TM-742 A/E

TM-942 A

SERVICE MANUAL

Service Bulletin

Control Unit (X53-3460 A/2)
Foil Side View

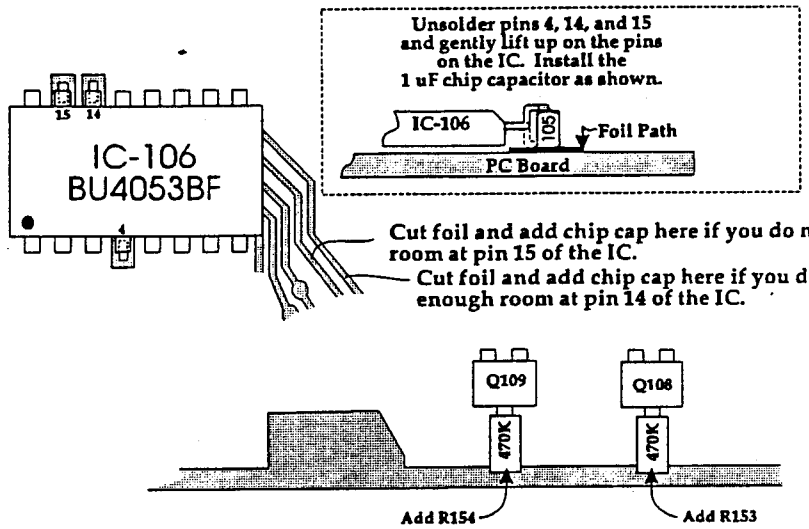
Several TM-742/942 owners have complained of a popping noise when the squelch opens or closes, even when the volume is turned down.

We have found that the following changes will reduce or eliminate this noise.

Qty	Description	Kenwood Part No.	Circuit Description
3	470 K ohm Chip resistor.	RK73FB2A474J	R152, 153, 154
3	1 uF Chip capacitor	CK73FF1C105Z	NA

1. Carefully unsolder pins 4, 14, and 15 of IC-106 on the foil side of the Control Unit (X53-3460 A/2).
2. Gently lift up on the unsoldered pins of the IC and place a 1 uF chip capacitor as shown in the accompanying diagrams.
3. Solder the capacitors to the foil and to the pins of the IC.
   Note: If you do not have enough room to install the capacitors on pins 14 and 15 you will need to cut the circuit foil and install the capacitors in the alternate positions indicated in the diagram.
4. Install resistors R154 and R153 as shown.
5. Install resistor R152 on the component side of the board as shown in the diagram.

Front Panel Area

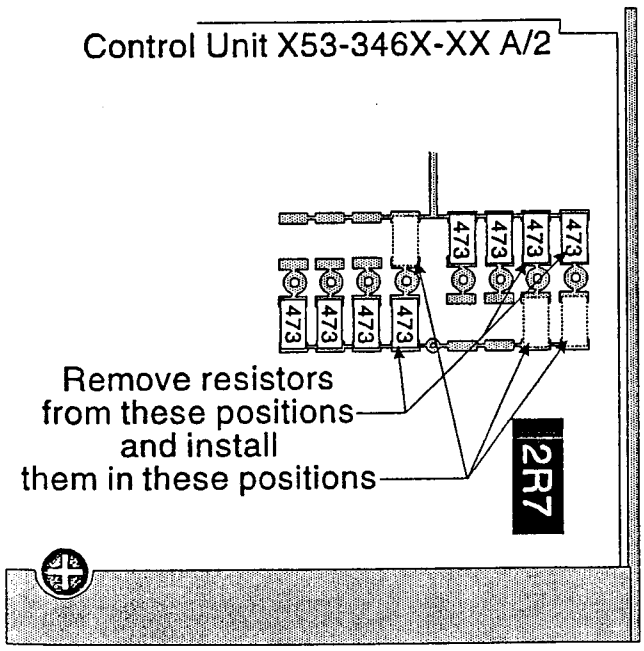
1. Detach the front panel from the main chassis.
2. Remove the bottom cover of the transcevier by removing the 4 screws on the bottom of the cover and loosening the 4 screws on the sides of the unit.
3. Orient the radio so the bottom is up and the front panel area is near your chest. Near the front panel area you will find a large board, this is the Control Unit.
4. Remove the chip resistors noted in the diagram below, and reinstall them as shown.

5. Reinstall the bottom cover of the transceiver, and reattach the front panel.
6. Reset the microprocessor. Press and hold the MR key while the power is switched on. Then release the MR key. This will erase all operator programmed data!
7. The frequency range after modification will be:

28 MHz Band:	RX:	18.0 thru 54.0 MHz
	TX:	26.0 thru 45.0 MHz
50 MHz Band:	RX:	40.0 thru 90.0 MHz
	TX:	46.0 thru 76.0 MHz
144 MHz Band:	TX:	136.0 thru 174.0 MHz.
220 MHz Band:	RX:	215.0 thru 260.0 MHz.
	TX:	215 .0thru 235.0 MHz.
440 MHz Band:	TX:	410.0 thru 470.0 MHz.
1.2 GHz Band:	RX/TX:	1100.0 thru 1400.0 MHz.

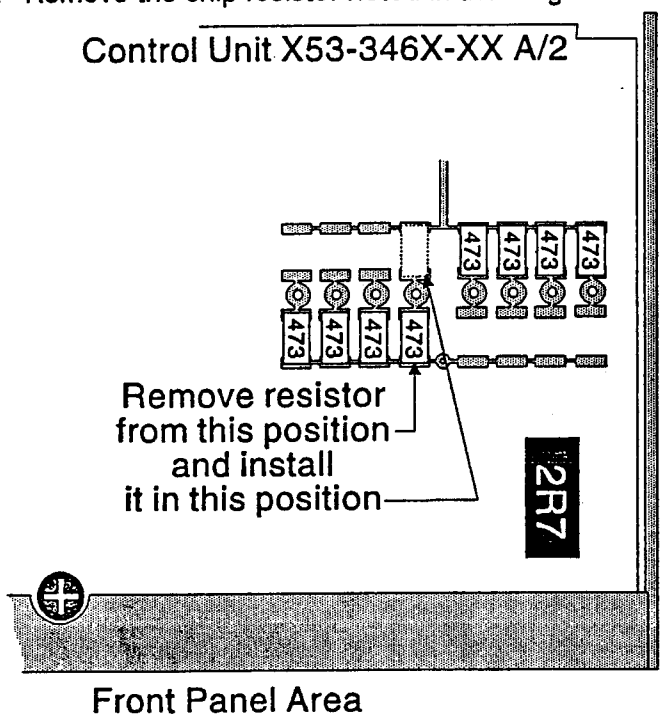
1. Detach the front panel from the main chassis.
2. Remove the bottom cover of the transcevier by removing the 4 screws on the bottom of the cover and loosening the 4 screws on the sides of the unit.
3. Orient the radio so the bottom is up and the front panel area is near your chest. Near the front panel area you will find a large board, this is the Control Unit.
4. Remove the chip resistor noted in the diagram below, and reinstall it as shown.

5. Reinstall the bottom cover of the transceiver, and reattach the front panel.
6. Reset the microprocessor. Press and hold the MR key while the power is switched on. Then release the MR key. This will erase all operator programmed data!
7. The frequency range after modification will be:

144 MHz Band
RX: Unchanged 118 MHz thru 174 MHz.
TX: 142.000 MHz thru 152.000 MHz.
